## Access Compliance Report Public Rights-of-Way (Curb Ramps)

Intersection ID: 10034609Main Street: PLANTATION\_CENTER\_DRCross Street: N/ALocation:NADA ID: FDF554C25DB8Ramp Type: ParaInitial Pass/Fail: FailOverall Compliance: NoSeverity Score: 13.75

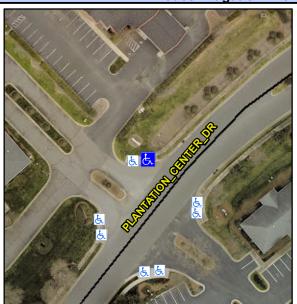
R304.3.2, R304.5.3

Compliance Description		Data	Compliance Description		Data
N/A	Ramp Length LT (in)	58.0	N/A	Ramp Length RT (in)	64.0
Yes	Ramp Width LT (in)	96.0	Yes	Ramp Width RT (in)	96.0
No	Ramp Slope LT (%)	8.7	Yes	Ramp Slope RT (%)	6.0
Yes	Ramp XSlope LT (%)	0.2	No	Ramp XSlope RT (%)	2.1
N/A	Landing Length (in)	N/A	N/A	DWS Provided?	N/A
N/A	Landing Width (in)	N/A	N/A	DWS Contrast?	N/A
N/A	Landing Slope (%)	N/A	N/A	DWS Length (in)	N/A
N/A	Landing X Slope (%)	N/A	N/A	DWS Full Width?	N/A
N/A	Landing Curb? (Y/N)	N/A	N/A	DWS Offset (in)	N/A
N/A	Shared Landing?	N/A			
N/A	Gutter Ponding?	N/A	N/A	Gutter Slope (%)	N/A
N/A	Gutter Lip Ht (in)	N/A	N/A	Gutter X Slope (%)	N/A
N/A	Painted X Walk1?	No	N/A	Painted X Walk2?	N/A
	X Walk 1 Direction	To SE		X Walk 2 Direction	N/A
N/A	X Walk 1 Width (in)	N/A	N/A	X Walk 2 Width (in)	N/A
	X Walk 1 Slope (%)	1.6		X Walk 2 Slope (%)	N/A
	X Walk 1 X Slope (%)	1.6		X Walk 2 X Slope (%)	N/A
N/A	Ramp inside XWalk1?	N/A	N/A	Ramp inside XWalk2?	N/A

Remove & Replace Entire Ramp.
